Planning

Villages-West-Main-Final-Plat 8-13-2018+.pdf

Villages-West-Main-Final-Plat Rev 10-16-18.pdf

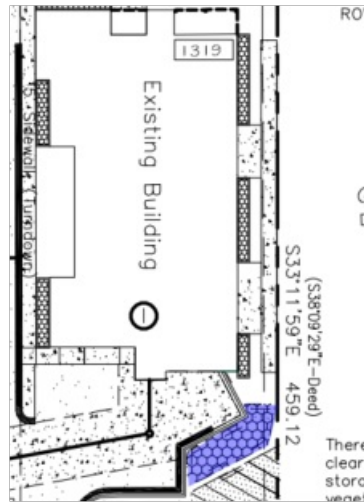
Applicant to label the bioretention area hatching highlighted below, or include it in the legend.
